Product / Process Change Notification (PCN)

PCN #: PCN_IndXHMI_20190519

Affected Series: WE-XHMI – 6030 ,6060, 8080, 1090, 1510;
744393xxx

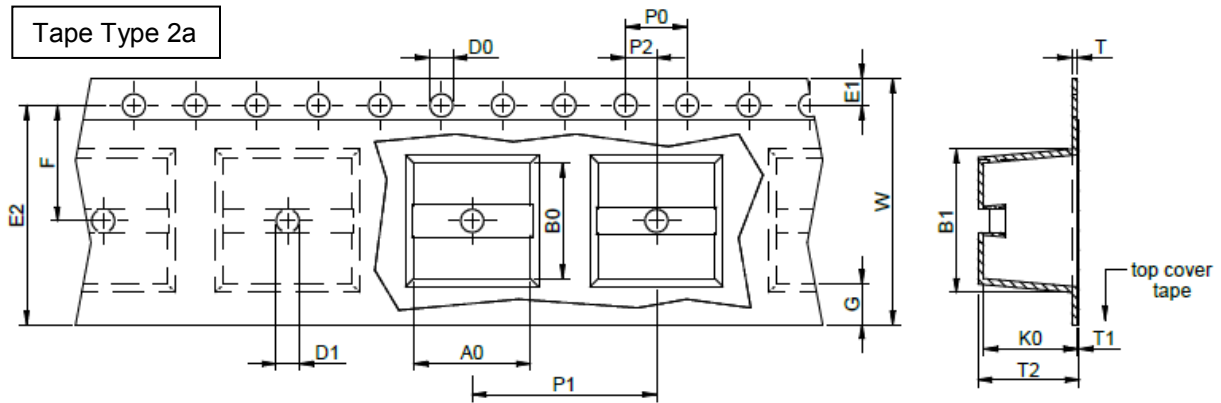
Due to packaging optimizations, Würth Elektronik will change the carrier tape dimensions for the sizes 6030, 6060, 1090 and because of a database mismatch Würth Elektronik will update certain parameters and tolerances in the packaging specification.

The **carrier tape dimension changes** for the sizes 6030, 6060, 1090 will increase the efficiency of the pick and place process. Any further change is aimed to correct database mismatches to be aligned with the international packaging standard IEC 60286-3:2013.

Size: 6030	Values in [mm]									
Before change	A0	B0	W	T	T1	T2	K0	D1	E1	E2
tolerance	±0,1	±0,1	±0,2	±0,05	typ.	±0,1	±0,1	±0,1	±0,1	±0,1
specification	7,60	7,50	16,00	0,40	0,15	3,80	3,60	1,50	0,75	12,50
After change	A0	B0	W	T	T1	T2	K0	D1	E1	E2
tolerance	typ.	typ.	+0,3/ -0,1	ref.	max.	typ.	typ.	min.	±0,1	min.
specification	7,00	6,80	16,00	0,40	0,10	3,90	3,70	1,50	1,75	14,25

Size: 6060	Values in [mm]									
Before change	A0	B0	W	T	T1	T2	K0	D1	E1	E2
tolerance	±0,1	±0,1	±0,2	±0,05	typ.	±0,1	±0,1	±0,1	±0,1	±0,1
specification	7,60	7,50	16,00	0,40	0,15	6,50	6,40	1,50	0,75	12,50
After change	A0	B0	W	T	T1	T2	K0	D1	E1	E2
tolerance	typ.	typ.	+0,3/ -0,1	ref.	max.	typ.	typ.	min.	±0,1	min.
specification	7,00	6,80	16,00	0,40	0,10	6,50	6,40	1,50	1,75	14,25

Size: 1090	Values in [mm]									
Before change	A0	B0	W	T	T1	T2	K0	P1	D1	E2
tolerance	±0,1	±0,1	±0,2	±0,05	typ.	±0,1	±0,1	±0,1	±0,1	±0,1
specification	12,40	11,30	24,00	0,50	0,20	10,30	9,80	20,00	1,50	22,25
After change	A0	B0	W	T	T1	T2	K0	P1	D1	E2
tolerance	typ.	typ.	+0,3/ -0,1	ref.	max.	typ.	typ.	±0,1	min.	min.
specification	12,10	11,00	24,00	0,50	0,10	9,60	9,40	16,00	1,50	22,25

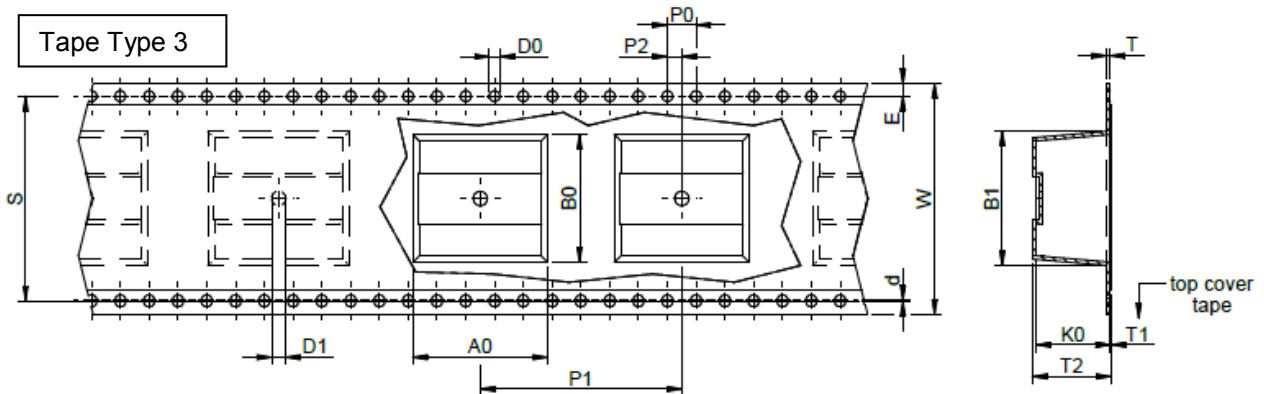
Size: 8080	Values in [mm]							
Before change	A0	B0	W	T	T1	T2	K0	E2
tolerance	±0,1	±0,1	±0,2	±0,05	typ.	±0,1	±0,1	±0,1
specification	9,00	8,85	24,00	0,60	0,10	8,00	7,90	22,25
After change	A0	B0	W	T	T1	T2	K0	E2
tolerance	typ.	typ.	+0,3/ -0,1	ref.	max.	typ.	typ.	min.
specification	9,00	8,85	24,00	0,60	0,10	8,00	7,90	22,25

Size: 1510	Values in [mm]									
Before change	A0	B0	W	T	T1	T2	K0	D1	S	Tape Type 2a
tolerance	±0,1	±0,1	±0,2	±0,05	typ.	±0,1	±0,1	±0,1	±0,1	
values	16,90	15,90	32,00	0,50	0,20	10,8	10,30	1,50	28,50	Polystyrene
After change	A0	B0	W	T	T1	T2	K0	D1	S	Tape Type 3
tolerance	typ.	typ.	±0,3	ref.	max.	typ.	typ.	min.	±0,1	
values	16,90	15,90	32,00	0,50	0,10	10,8	10,30	2,00	28,40	Polystyrene
